**PM7367**

**FREEDM-32P32**

**REVISION A DEVICE ERRATA**

**ISSUE 2: NOVEMBER 2001**

#### 2.1.1.1 Figure 2.1: Receive Packet Descriptor.

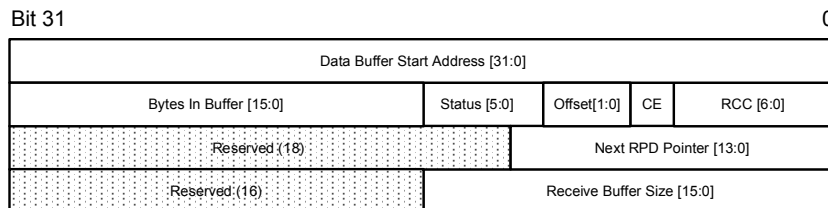
When ALL of the following conditions are met:

1. The offset[1:0] field of a Receive Packet Descriptor (RPD) is non-zero.
2. The STRIP bit of register "**0x204 RHDL Indirect Channel Data Register #1**" is logic one.
3. The incoming packet payload is smaller than the FCS field (2 bytes for CRC-CCITT or 4 bytes for CRC-32).

The value in the "Bytes in Buffer [15:0]" field of the RPD can be underflowed. That is, this field will contain a negative value. If this field is interpreted as an unsigned integer, the content of the buffer can be erroneously interpreted as a very large number.

The following are **independent** workarounds for this error:

1. If the Offset[1:0] bits of RPD are set to zero, this problem will not occur.
2. If the STRIP field of "**0x204 RHDL Indirect Channel Data Register #1**" is set to zero, this problem will not occur.
3. If the buffer size is not larger than 32K Bytes, the most significant bit of the "Byte in Buffer" field can be used as a sign bit. The device software should discard RPDs that contain a negative "Bytes in Buffer" value.

For every RPD, the driver software can compare the "Bytes in Buffer[15:0]" field to ensure that it is smaller than or equal to "Receive Buffer Size[15:0]".

#### 2.3.1.1 Figure 2.2: PCI Interface Timing

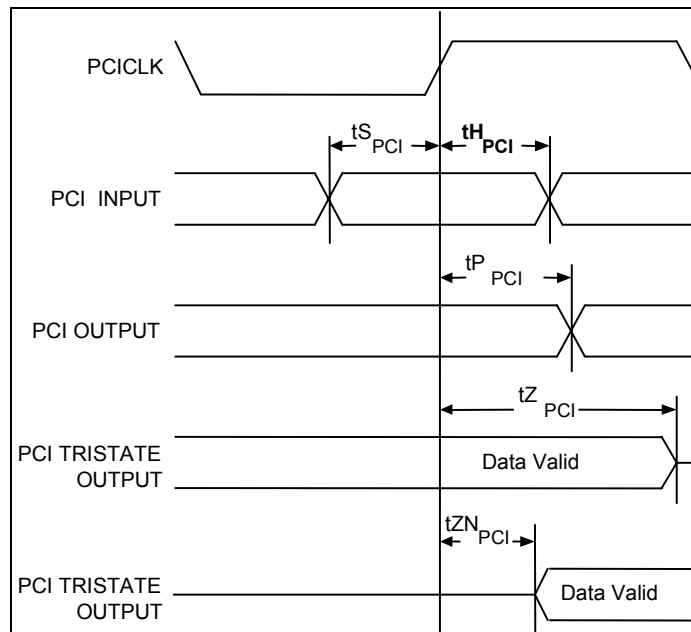
PCI Input and Bi-directional signals require a minimum hold time ( $t_{H_{PCI}}$ ) of 1 ns with respect to PCICLK.

The PCI 2.1 specification requires PCI outputs to have a minimum 2 ns propagation delay. The clock skew between FREEDM-32P32 and other PCI devices in a system must therefore be kept below 1 ns to ensure correct operation.
